Project No. 018-150H

**RE: SITE CONTAMINATION CAPPING
FLIPSIDE CIRCUS USE AREAS
221 MACARTHUR AVENUE, HAMILTON**

DRAWING No: 3 REV: B

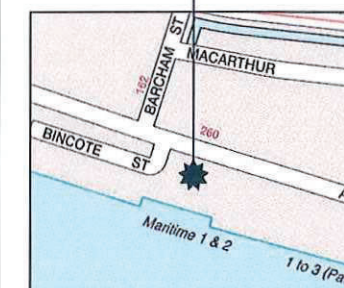
In addition, we understand that part of the DA for the Flipside Circus proposal includes the use of areas outside the immediate site for transport set down and pick up and pedestrian access. Comment on these areas in relation to site contamination is also required. The extent of the site including set down and pick up and pedestrian access areas is shown on Drawing No. 3 Rev B attached. The areas external to the site include:

- an access road and car parking extending from the southern end of Bincote Street adjacent to the southern boundary of the Tank site, through the northern portion of the Maritime 03 Park and into the north western portion of the Think Street site;
- driveway access through the northern portion of the Tank site comprising ingress from Bincote Street and egress to MacArthur Avenue on concrete driveway with green space inside the loop; and
- footpath area on Macarthur Avenue extending along the Flipside Circus site boundary.

Within the transport set down and pick up and pedestrian access areas, we understand that existing hard stand site capping in the driveway and car parking areas will be retained as will the existing footpath along MacArthur Avenue. The proposed green space area within the northern portion of the Tank site includes an area currently comprising two existing open inground concrete lined pits, the content of these is unknown, however, it is proposed that as part of the development works, these will be pumped out and filled with clean fill. Past sampling and testing of soil on the Tank site has indicated that the soils sampled across the site meet the published criteria for public open space. Considering the nature of the use of each of these areas, the proposal to retain existing hard stand capping over most of the surface, the existing results for the Tank site and the proposal to pump out and backfill the two in-ground pits, it is considered that these transport set down and pick up and pedestrian access areas are suitable for their intended use from a contaminated land perspective.
